Errata Sheet

Rel. 1.1, 2012-04-04

Device	**TC1724F/N, TC1728F/N**
Marking/Step	**ES-AB, AB**
Package	**see Data Sheet**

This Errata Sheet describes the deviations from the current user documentation.

Figure 1 Timing concerning equidistant multiple timers

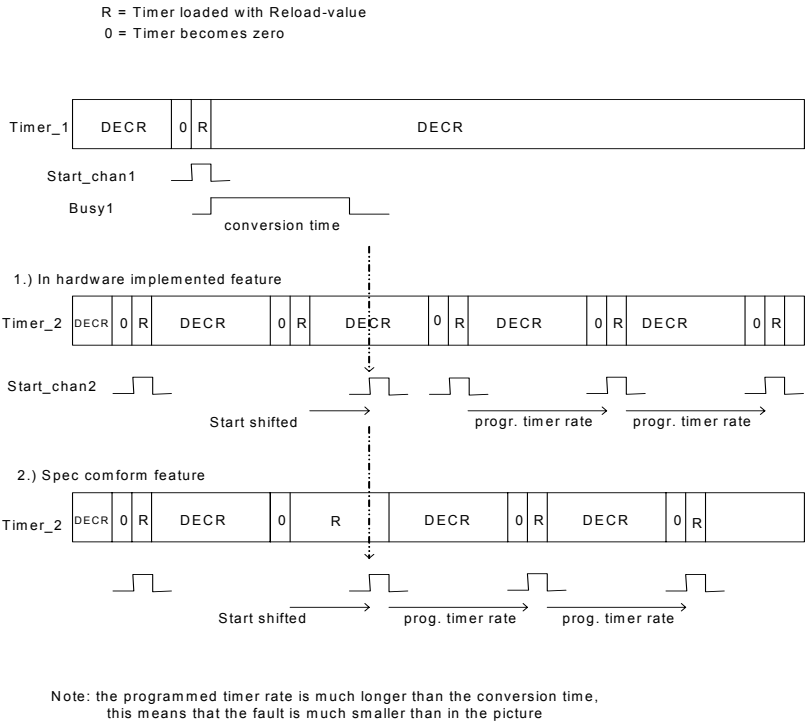
Timer_1 becomes zero and starts a conversion. Timer_2 becomes zero during this conversion is running and sets the conversion-request-bit of channel_2. At the end of the conversion for channel_1 this request initiates a start for channel_2. But the Timer_2 is reloaded only when setting the request-bit for channel_2 and is decremented during the conversion of channel_1.

The correct behavior would be a reload when the requested conversion (of channel_2) is started.

Therefore the start of conversion for channel_2 is delayed by maximum one conversion-time. After this delay it will be continued with equidistant conversion-starts. Please refer to the following figure.

Use one timer base in combination with neighboring trigger and selection by software which result has to be taken into account.

Figure 4 $\overline{\text{PORST}}$ Redundancy Path

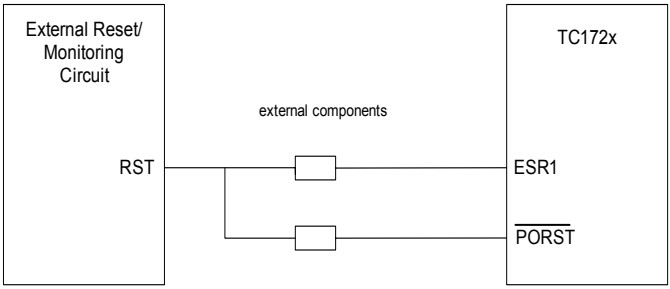
The $\overline{\text{PORST}}$ pad includes a strong pull-down device controlled by the EVRs. This allows pin $\overline{\text{PORST}}$ to be actively driven low upon a threshold violation of (at least one of) the monitored supply voltages. For the characteristics of this pull-down see parameter $\overline{\text{PORST}}$ pad output current $I_{DDPORST}$ in the Data Sheet.

Besides this (switchable) pull-down, the $\overline{\text{PORST}}$ pad has a permanent internal weak pull-up (see parameter Pull-Up current I_{PUH} in Data Sheet).

a) Connect the reset line additionally to the ESR1 pin (or other appropriate pins) to provide a redundant path to detect such a failure mode.

b) Activate internal voltage monitoring for external supply which acts as a redundant supply watchdog in addition to the supply monitoring carried out by the external regulator.
